TECHNICAL BULLETIN

VSCS ACTUATOR MOUNTING BRACKET REPAIR

All McDonnell Douglas Helicopter Systems (MDHS) MD900 helicopters, serial number 900-00010 thru 900-00051.

VSCS actuator attach bracket part number 900F2341255-101.

Figure 1. VSCS Actuator Attach Bracket Replacement

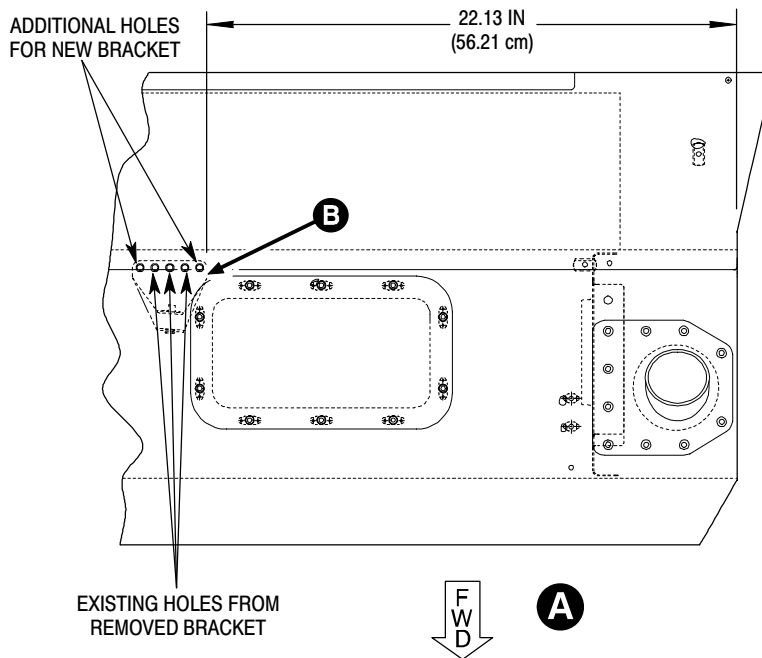
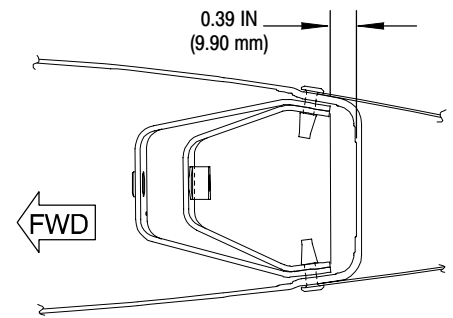
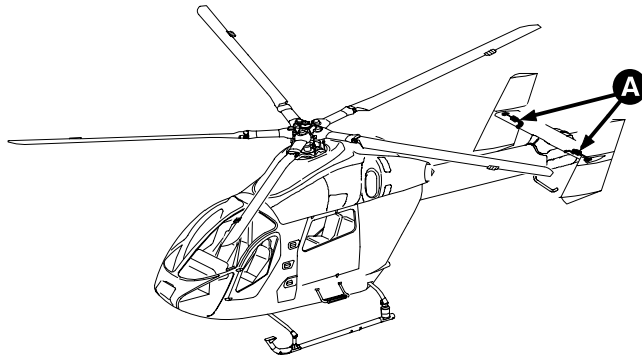
Aircraft in the field have experienced working of the VSCS actuator attach bracket attachment fasteners. Failure to repair this condition could result in the loss of control of the horizontal endplates on that side.

Procedures in this Bulletin provide owners and operators with instructions to replace their existing six (6) fastener VSCS actuator attach bracket part number 900F2341255-101 with an improved ten (10) fastener attach bracket part number 900F2341255-103, -104.

(1). Remove VSCS from inboard attach bracket (Ref. CSP-900RMM-2 Section 67-20-00).

(2). Remove existing VSCS actuator bracket.

- (3). Using new bracket locate bracket mounting holes in horizontal stabilizer assembly.

- (4). Drill additional mounting rivet holes to a number 19 drill.
(5). Position bracket in horizontal stabilizer assembly.

- (6). Install fasteners into horizontal stabilizer assembly and bracket. Wet install fasteners using primer MIL-P-23377.
(7). Connect VSCS actuator to new VSCS bracket (Ref. CSP-900RMM-2 Section 67-20-00).
(8). Perform a VSCS Operational Test (Ref. CSP-900RMM-2 Section 67-20-00).
(9). Record compliance to this Technical Bulletin in the Compliance Record section of the helicopter Log Book.
